# **Groundwater Application Review Summary Form**

Application # G- <u>18532</u>
Application # G- 18532  GW Reviewer Joe Kemps Date Review Completed: 8/14/2018
Summary of GW Availability and Injury Review:
[ ] Groundwater for the proposed use is either over appropriated, will not likely be available in the amounts requested without injury to prior water rights, OR will not likely be available within the capacity of the groundwater resource per Section B of the attached review form.
Summary of Potential for Substantial Interference Review:
[ ] There is the potential for substantial interference per Section C of the attached review form.
Summary of Well Construction Assessment:
[ ] The well does not appear to meet current well construction standards per Section D of the attached review form. Boute through Well Construction and Compliance Section.

Review of Water Right Application G-18532

### PUBLIC INTEREST REVIEW FOR GROUNDWATER APPLICATIONS

Figure 2. Well Location Map

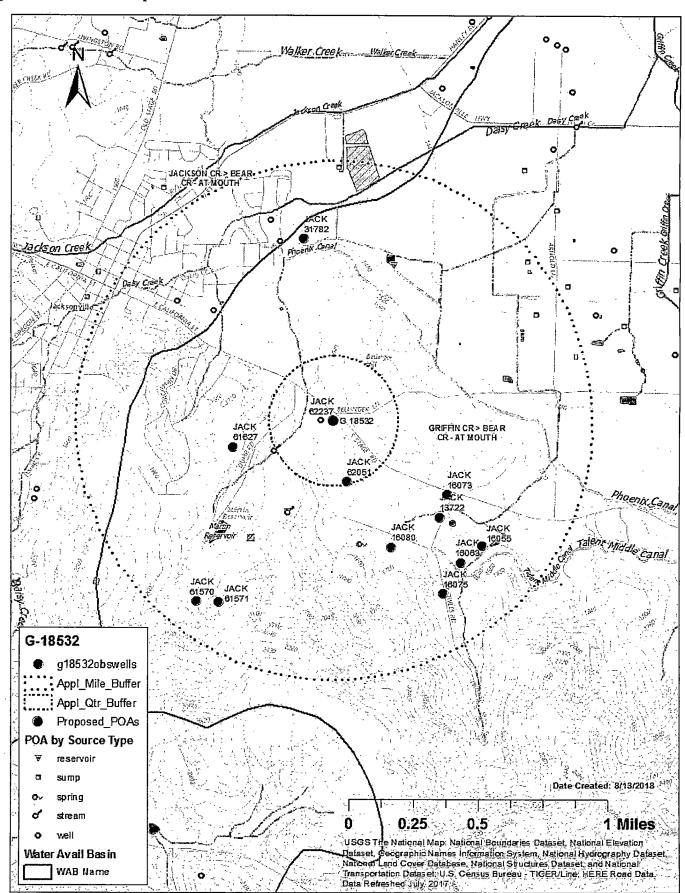
(dec <u>PO</u> wel	re is moderate groundwater development to the northwest, but considering the requested rate and the nature of the aquifer composed bedrock and local fracture systems), it is unlikely the proposed use will cause injury to senior users. There is a located less than 300 feet to the west (GR-2241), but it is located on the same tax lot. There is a likelihood of well-to-interference, but because they have the same owner, this review does not consider the potential injury or interference to particular POA.

Figure 3. Water-Level Trends in Nearby Wells

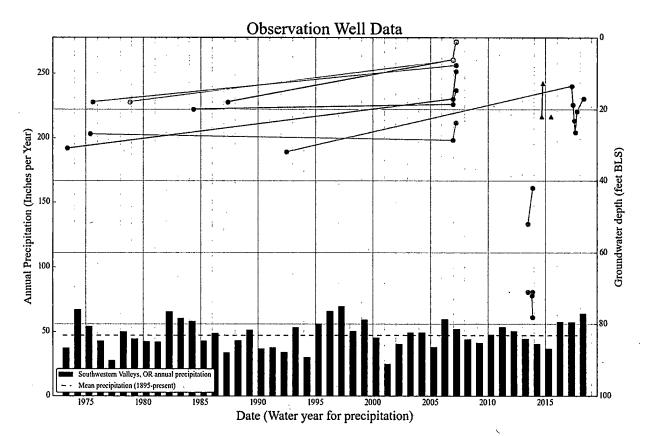
d.	<ul> <li>Well reconstruction is necessary to accomplish one or more of the above conditions. The problems that are likely to occur with this use and without reconstructing are cited below. Without reconstruction, I recommend withholding issuance of the permit until evidence of well reconstruction is filed with the Department and approved by the Groundwater Section.</li> <li>Describe injury —as related to water availability—that is likely to occur without well reconstruction (interference w/ senior water rights, not within the capacity of the resource, etc):</li> </ul>
В3.	met	bundwater availability remarks: The applicant's well would produce from a fractured bedrock aquifer system in assedimentary units of the Applegate Group. SWL measurements in nearby wells appear stable but lack the continuity to wide a preponderance of evidence that the resource is or is not over-appropriated (see Figure 3).
